## CONFLUENCE QUESTIONS & COMMENTS

SPU received many comments from the public regarding the 60% design of the Thornton Creek Confluence Improvement project throughout August. A compilation of those questions and comments is here.

60% DRAWINGS

THORNTON CREEK CONFLUENCE

SHEET 40 OF 51

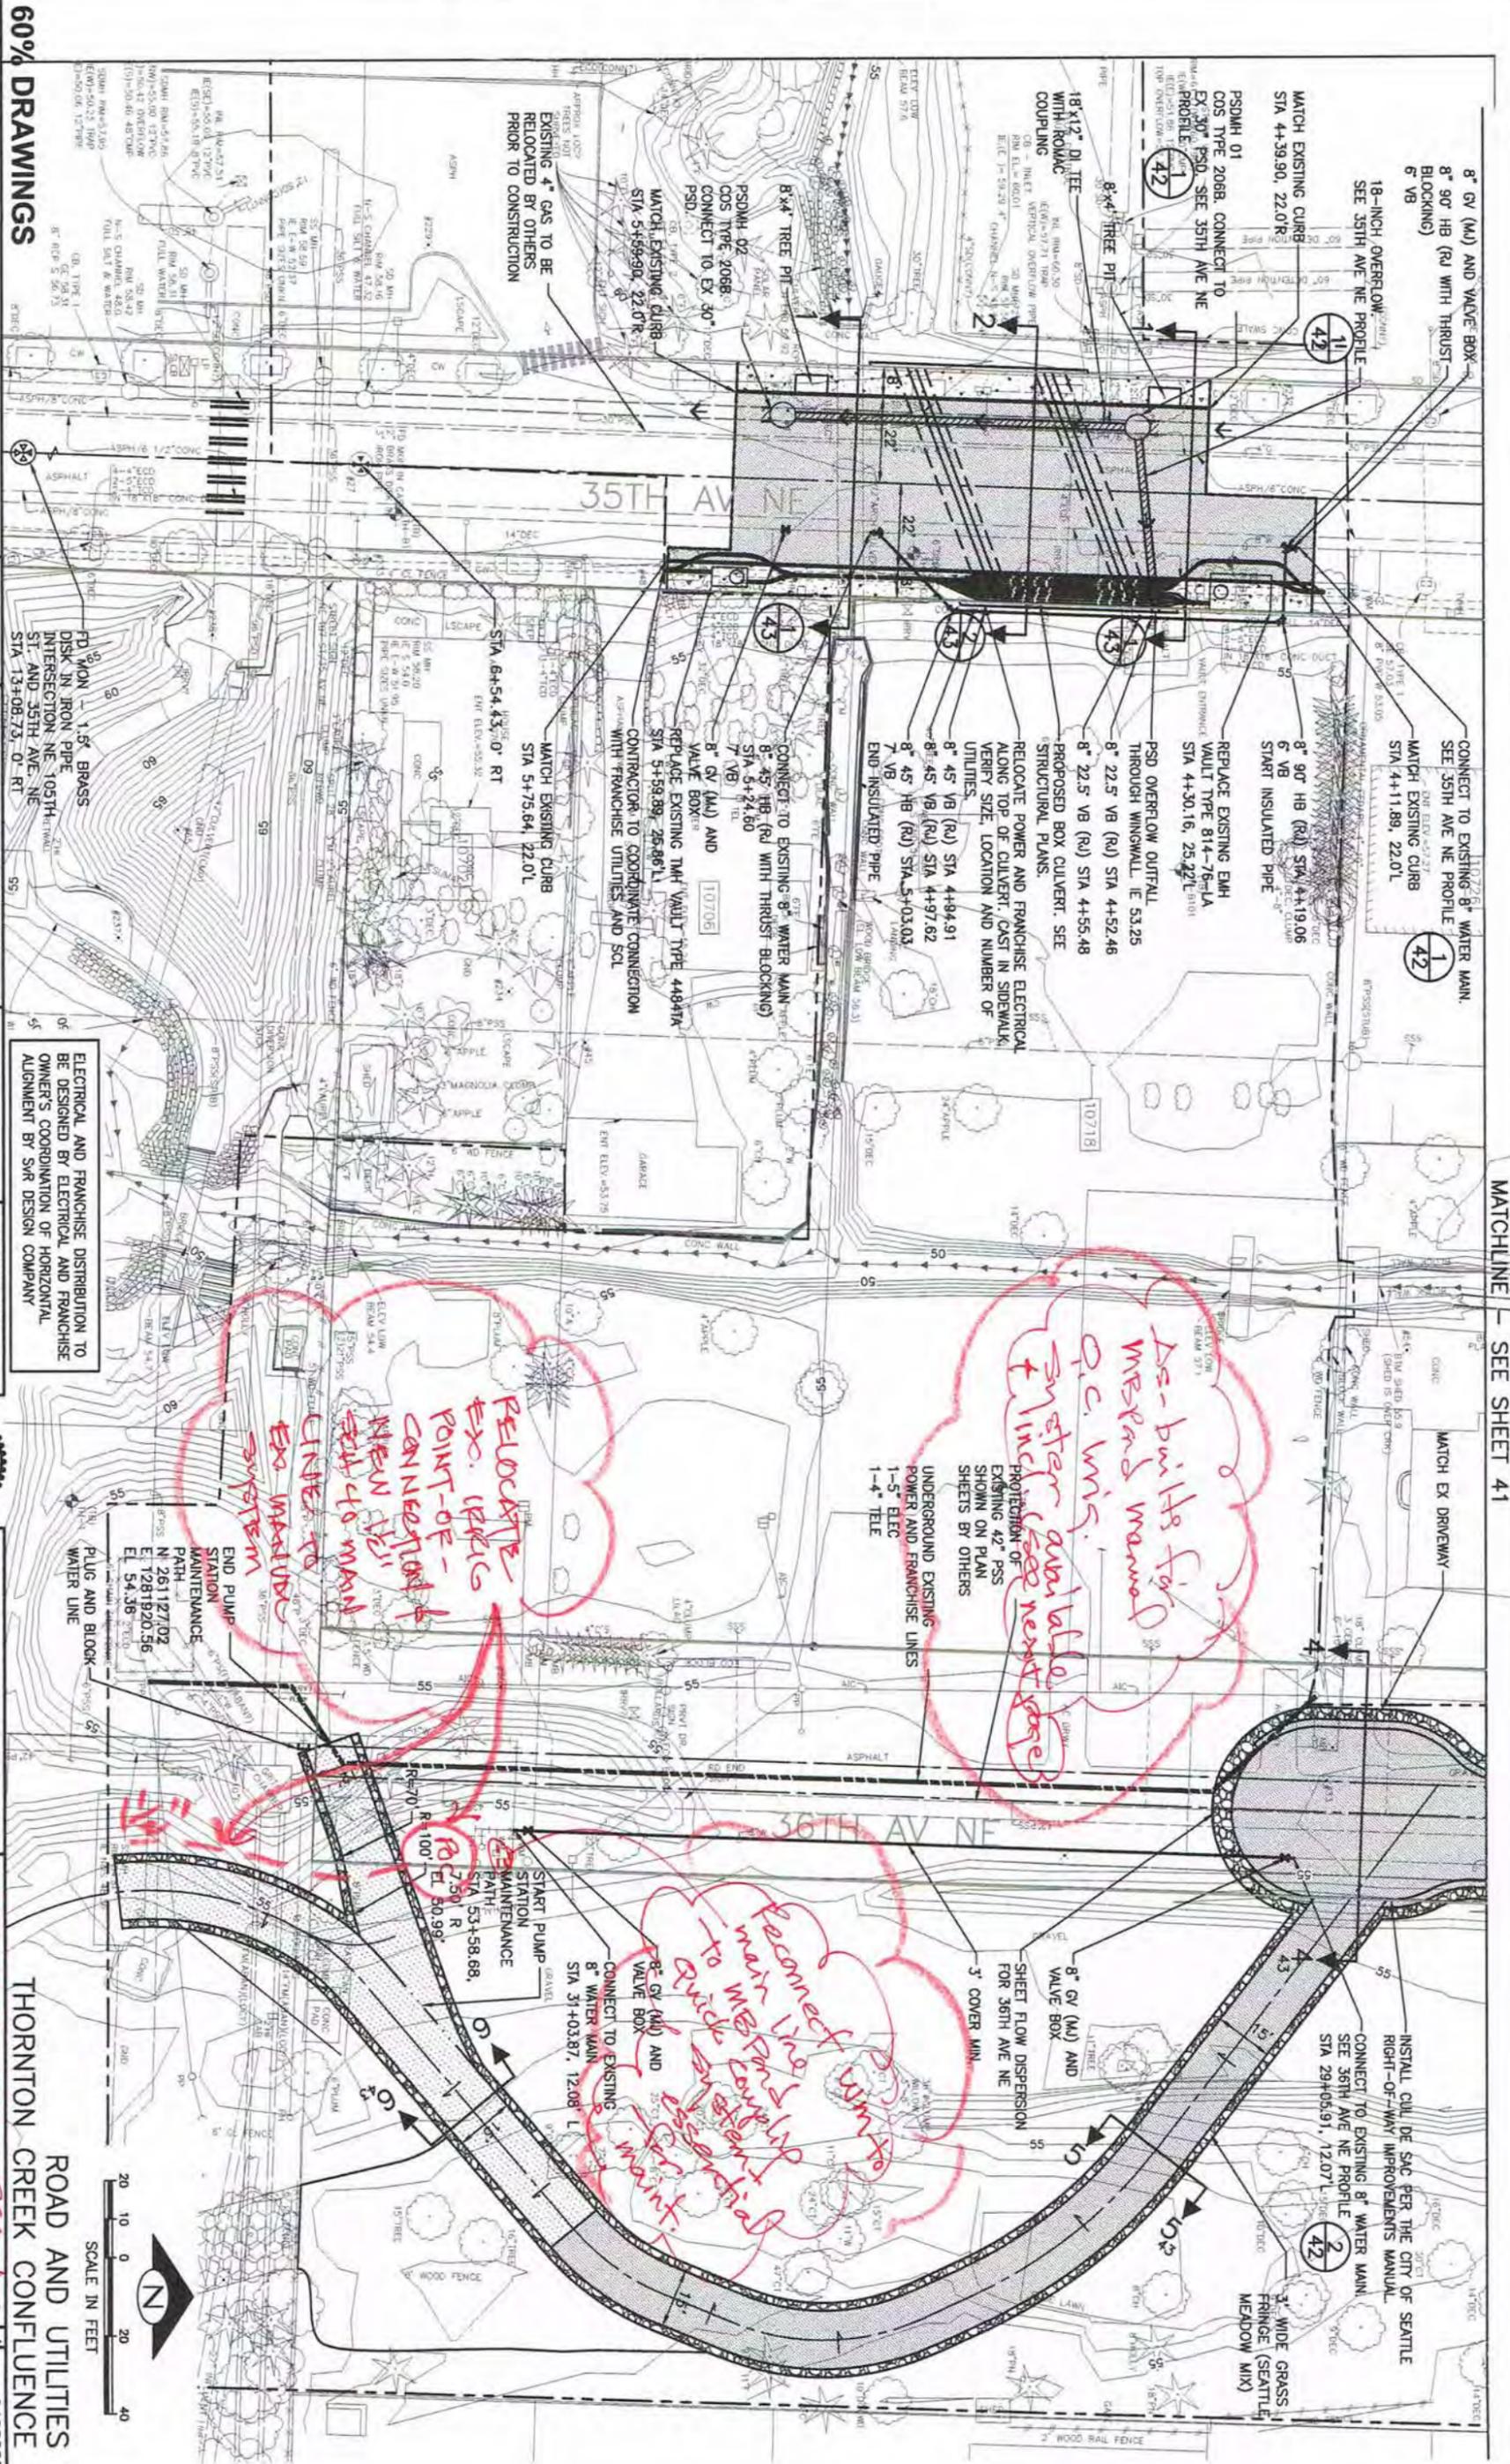
**Thornton Creek Confluence**  
 ROAD AND UTILITIES  
 COMMENETS FROM PC/ANR  
 THORNTON CREEK CONFLUENCE  
 8/13/12

IRRIGATION & SEEDING PLAN  
 REFLECTIVE REFUGE 1% FOR ART  
 MEADOWBROOK POND

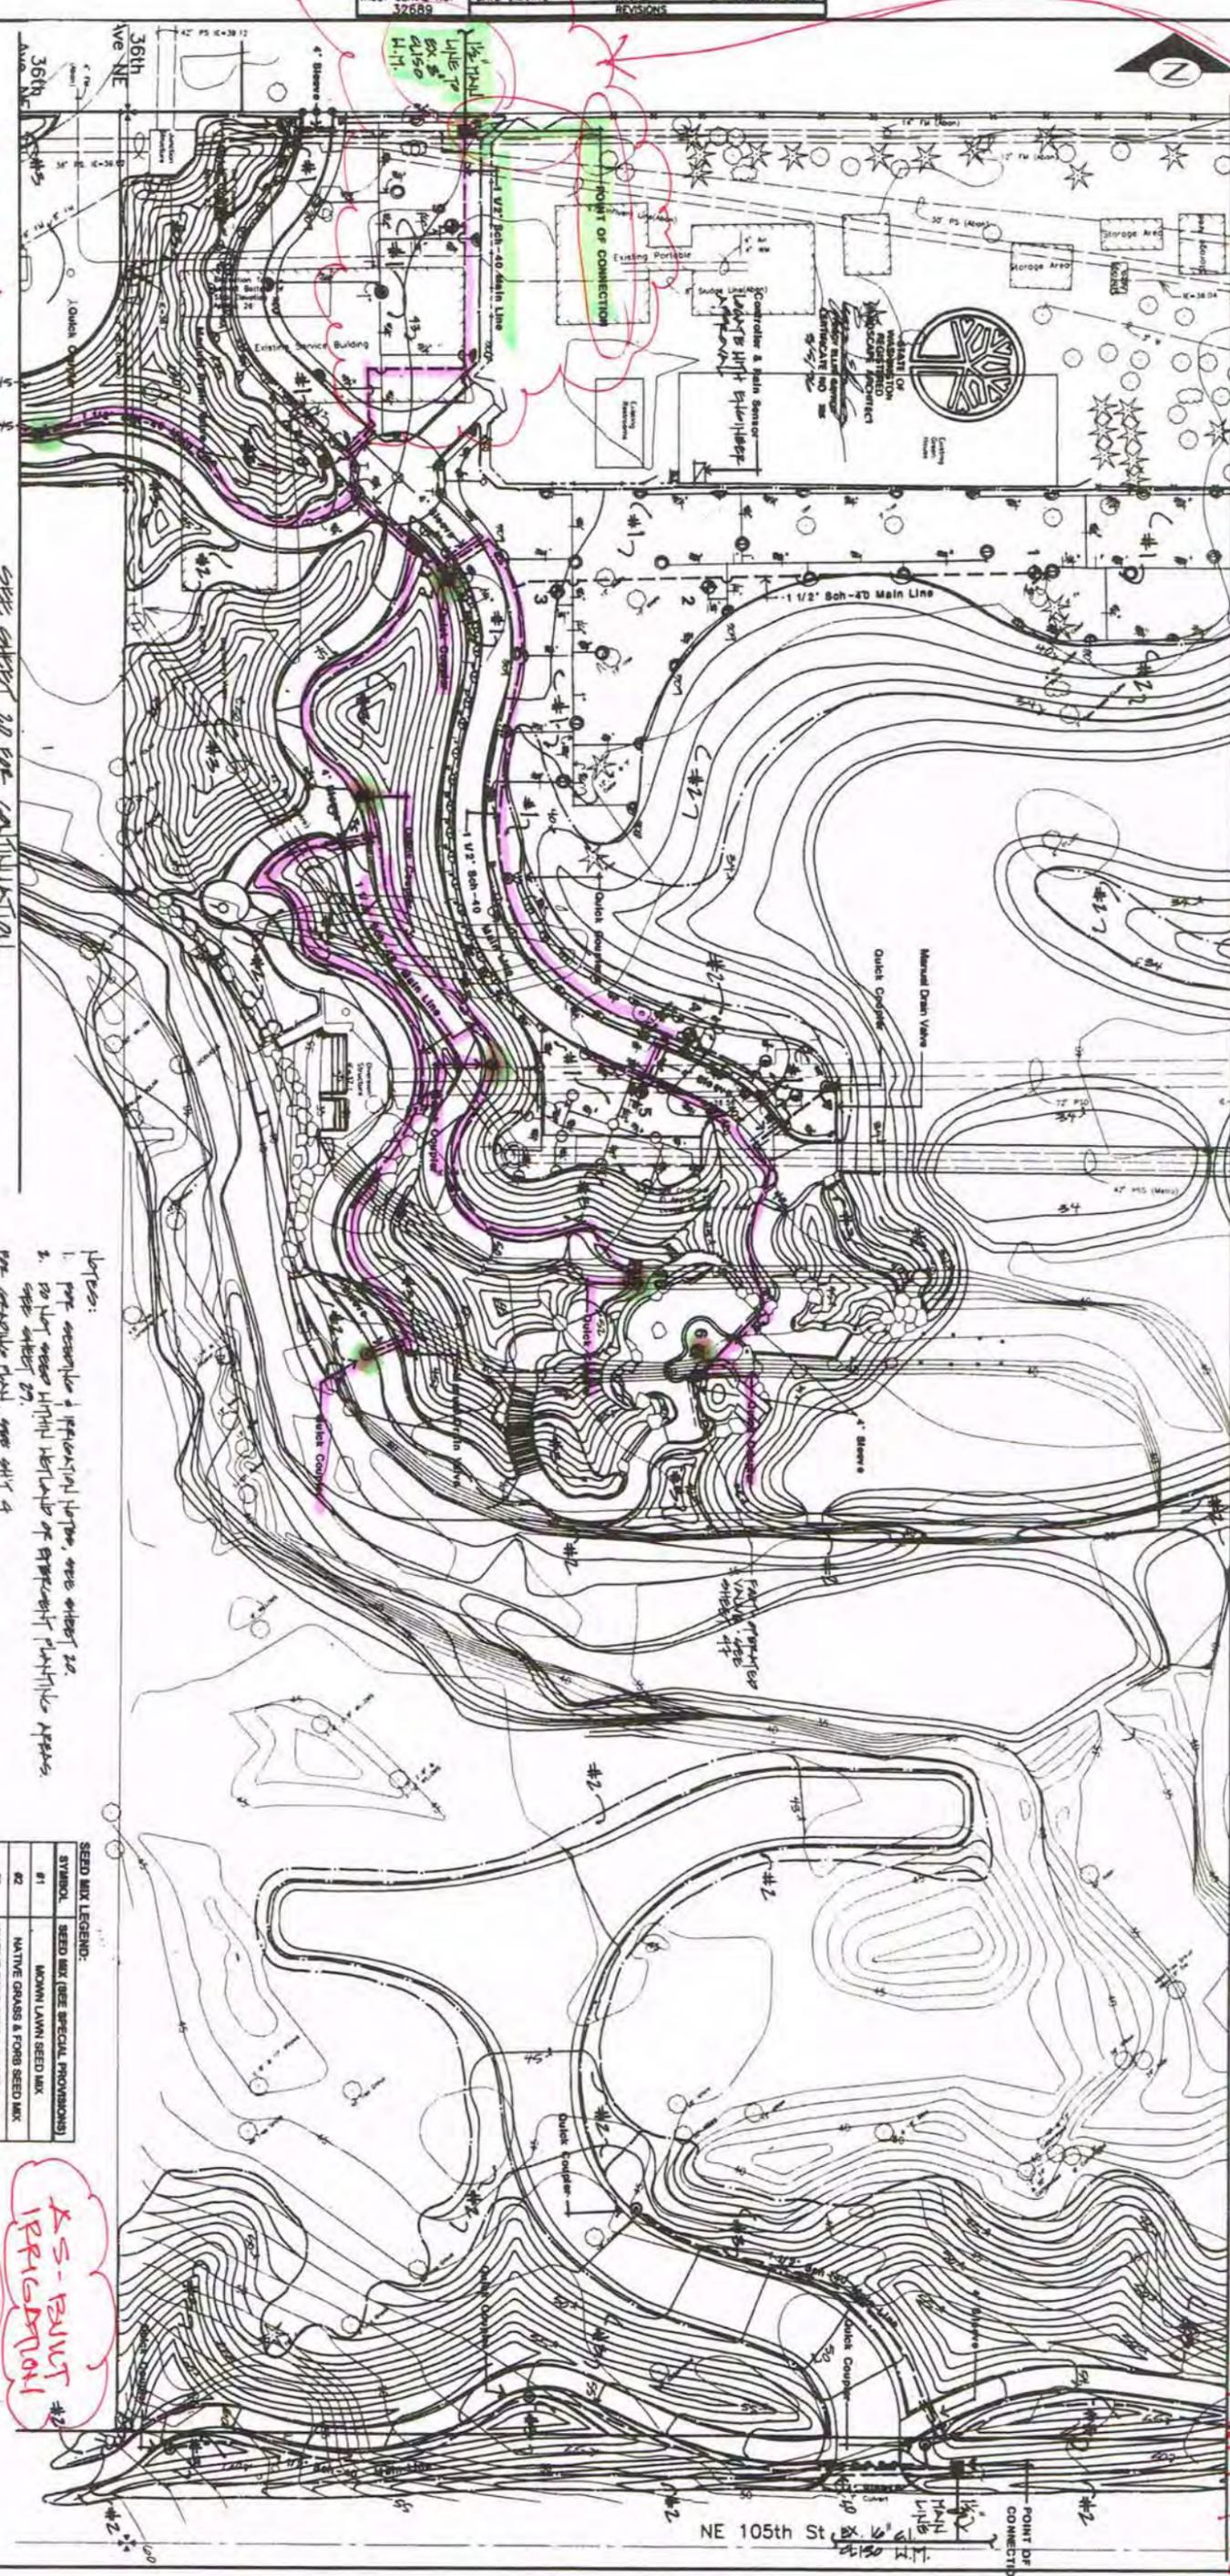
PLEASE  
 RELOCATE POINT-OF-CONNECTION & PROVIDE NEW  
 1 1/2" SOFT TO MAIN LINE TO RE-CONNECT TO EX. MANUAL QUICK COUPLER IRRIG. SUGGEST - essential for maintenance of art + more  
 SEE SHEET 18
